# SERVICE BULLETIN

**PRODUCT:** Computer Monitor  
**BULLETIN:** MON 97-003  
**MODEL:** CQB4147

## **SUBJECT: Improve the Horizontal Output Transistor Quality**

**Figure 1**

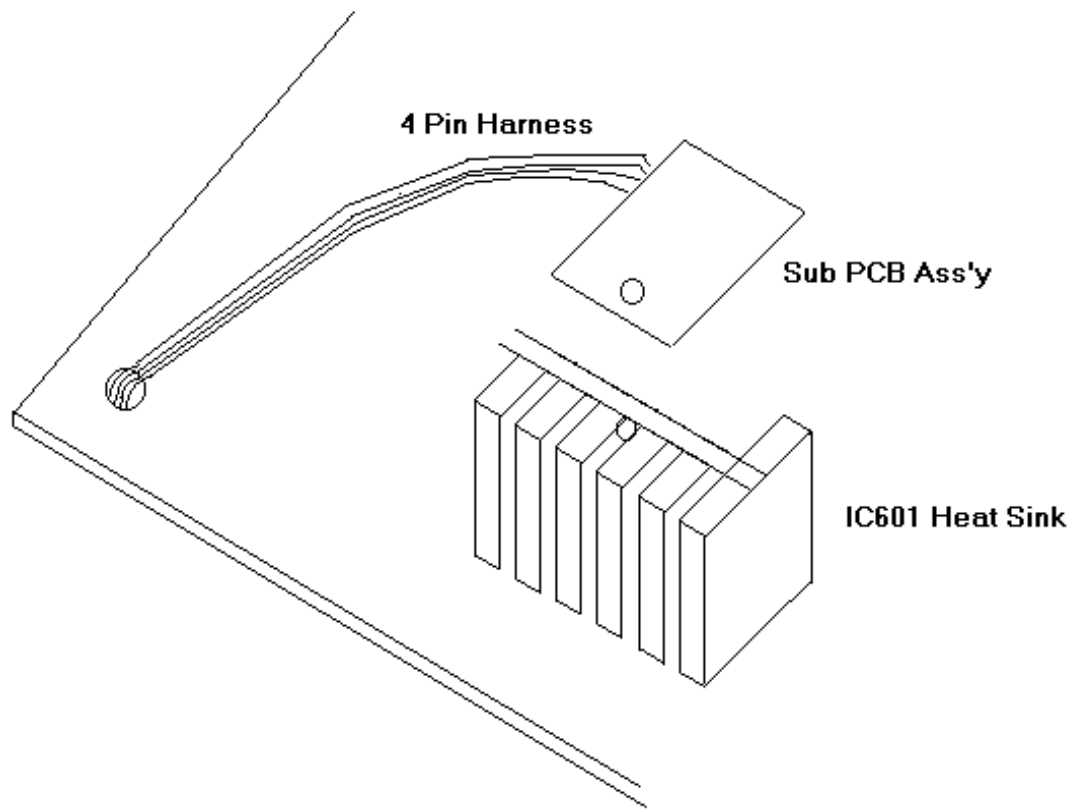
**BACKGROUND:** Q407 fails due to a transient pulse and current when mode switching from DOS to Windows. This occurs with a Matrox video card installed in the computer.

**SOLUTION:** Add a sub-PCB assembly as in figures 1 and 2 and a snubbing circuit for the horizontal output as in figure 3.

| ORIGINAL     |          |             | NEW         |                   |
|--------------|----------|-------------|-------------|-------------------|
| NA           | NA       | NA          | BH92-50106J | SUB-PCB ASSEMBLY  |
| NA           | NA       | NA          | BH39-40355S | 4 PIN CBF-HARNESS |
| NA           | NA       | NA          | 6003-000129 | TAPTITE SCREW     |
